EIC-Experimental Equipment
(BABAR/sPHENIX JLab Engineering Risk Assessment)

v2.00 - October 10th 2020 – updated risk tables

Document Title	Existing BABAR (sPHENIX) Solenoid - JLab Engineering Risk Assessment
Project	EIC Experimental Equipment
Purpose of document	To collate information pertaining to the long term engineering robustness and suitability of using the existing BABAR (sPHENIX) solenoid as the EIC detector solenoid
Version No.	3.00
Date	09.02.2020
Engineer	R. Fair
Reviewed by	R. Rajput-Ghoshal

Thermal shield

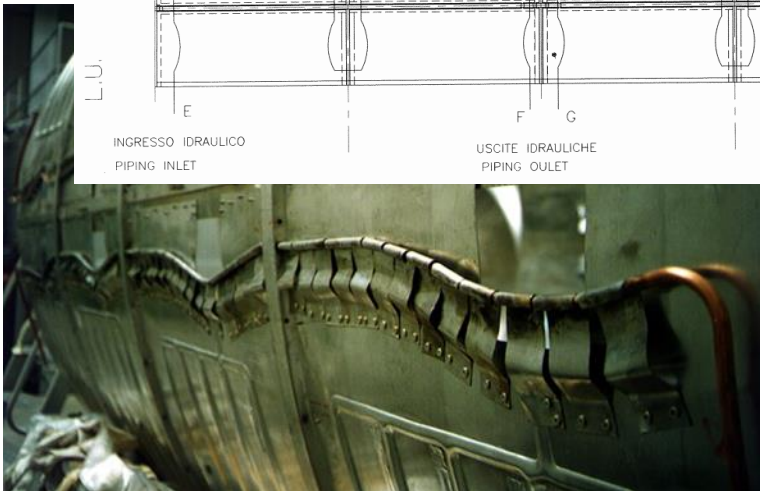
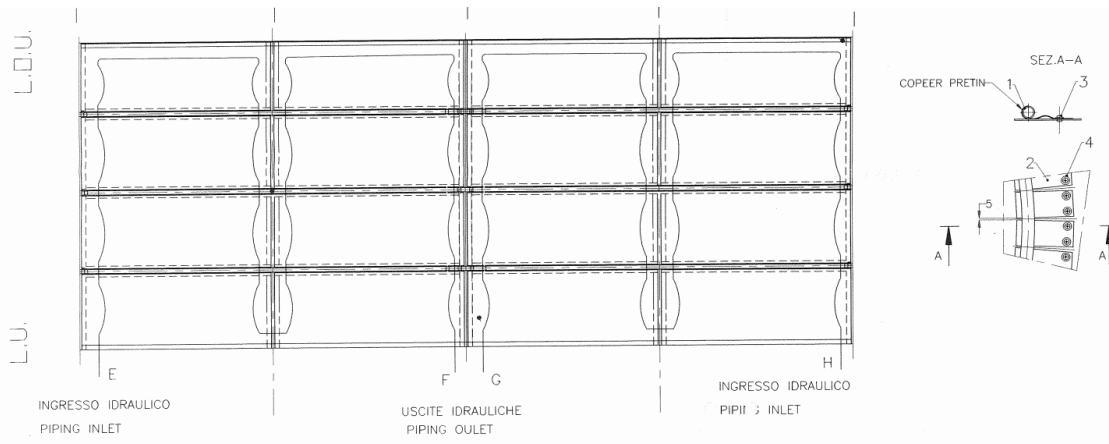
- There is a potential hard touch between the inner thermal shield and helium vessel (observed by the temperature sensor on the inner shield reading 4.2 K).

Solenoid Valve & Current Lead box

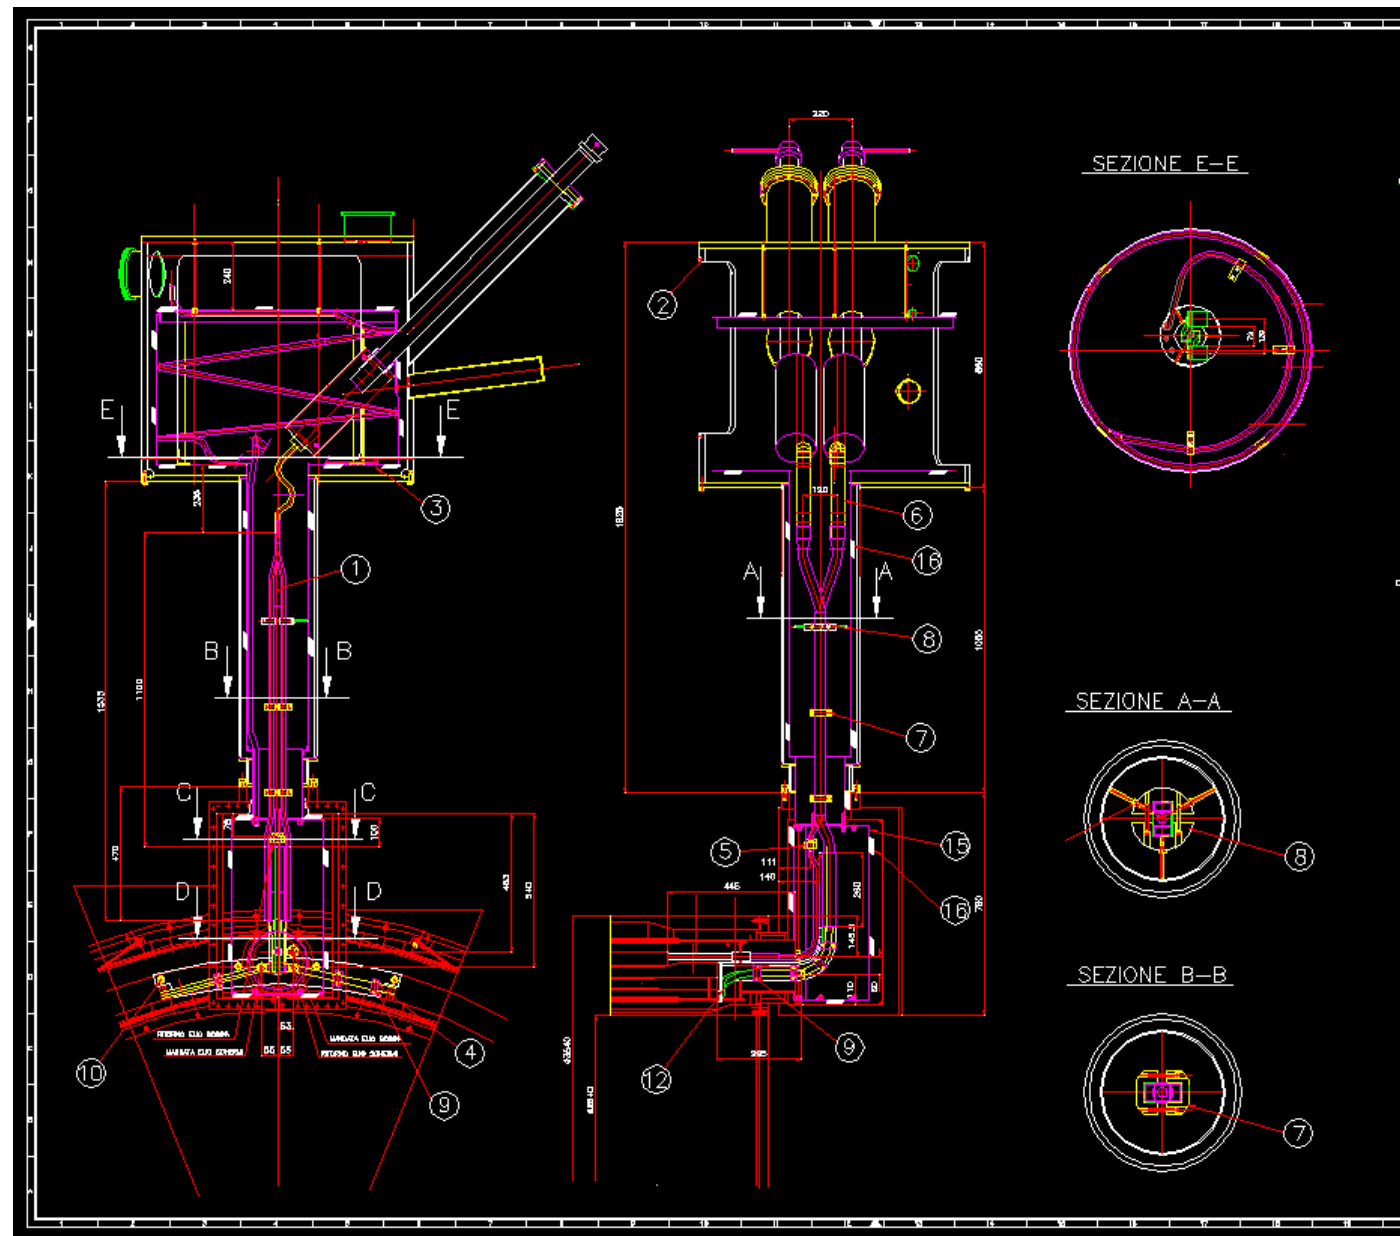
Distribution Valve Box	If the internal leak (noted earlier) is in the valve box, then this could be fixed. This leak has been confirmed by BNL to be within the valve box.	Leak could get worse or other leaks could open up. There could have been some overstressing of components during the transport from SLAC to BNL although there are no outward signs of this at present.	MODERATE	Fix leak – requires disassembly of valve box which should be easier than disassembly of the magnet.	LOW
Instrumentation	Strain gauges not working, temperature sensors on splices reading high, critical voltage taps lost or suspect.	Additional instrumentation could be lost or start mis-reading	MODERATE	Fix instrumentation - requires disassembly of magnet.	MODERATE (remains as moderate as the magnet requires disassembly which could lead to more rework)
Control System	One recorded failure while at high current, PXIe data acquisition system may not be adequate	Additional failures during operation	MODERATE	Replace complete system	LOW

- There also appears to be an internal leak when cold: 10^{-6} to 10^{-7} torr-liters/sec level – which is presently being managed by pumping during operation of the magnet. It is not clear whether this leak is within the magnet internal cryogenic system or within the valve box.

2. If the valve box is to be re-used, it should also be disassembled to inspect cooling pipework and to repair any leaks. *(Note: the one small leak remaining has been established to be within the valve box and should therefore be accessible)*

Power supply: Voltage Tap Locations

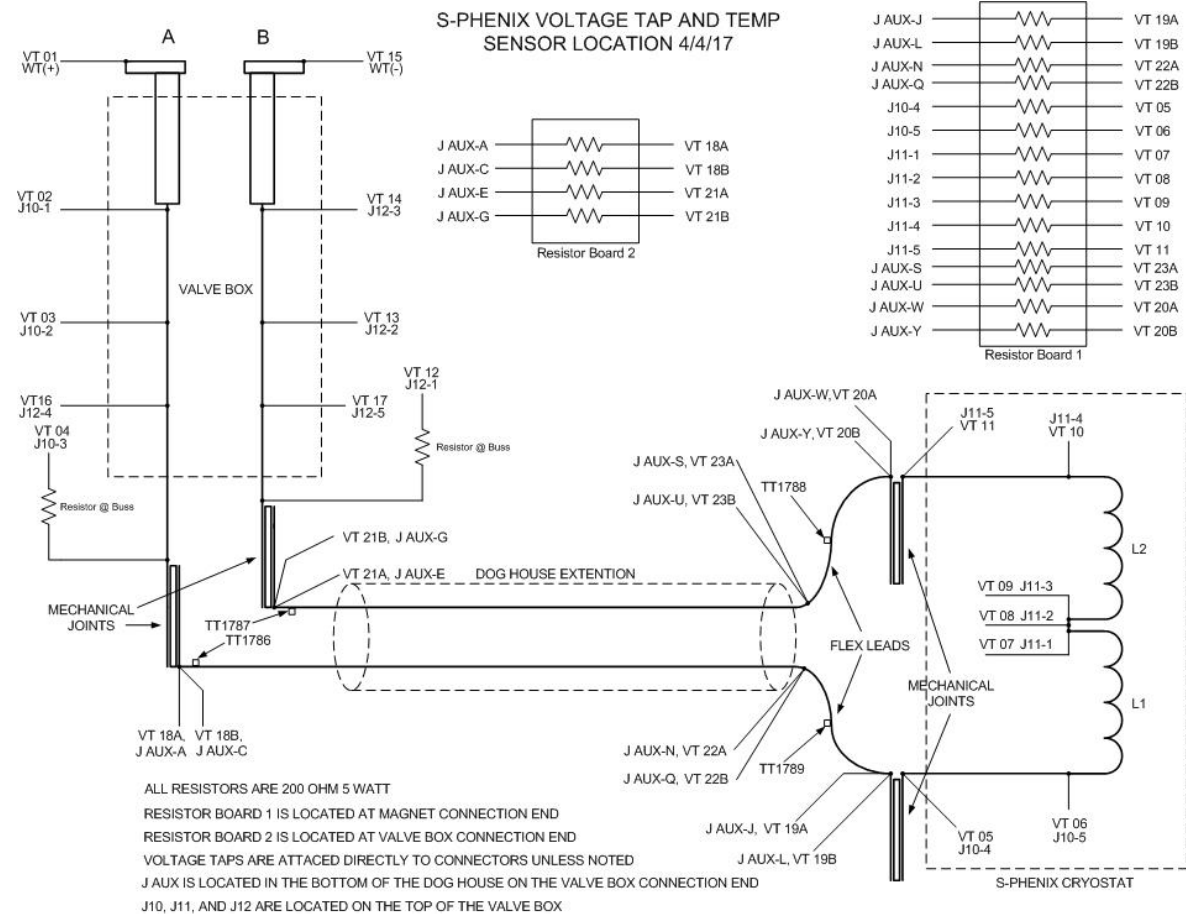
- At least one critical voltage tap has been lost and another ne considered suspect. They have therefore been eliminated from the quench detection and protection system. There is a high likelihood that additional voltage taps could be lost or could malfunction in the future.

Recommendations: Fit additional voltage taps and check all the others. This requires disassembly of the magnet, and unfortunately this could introduce another risk to the magnet, that of causing damage to the conductor or insulation during the soldering and fitting of new voltage taps. So this remedial action should be carefully planned before execution.
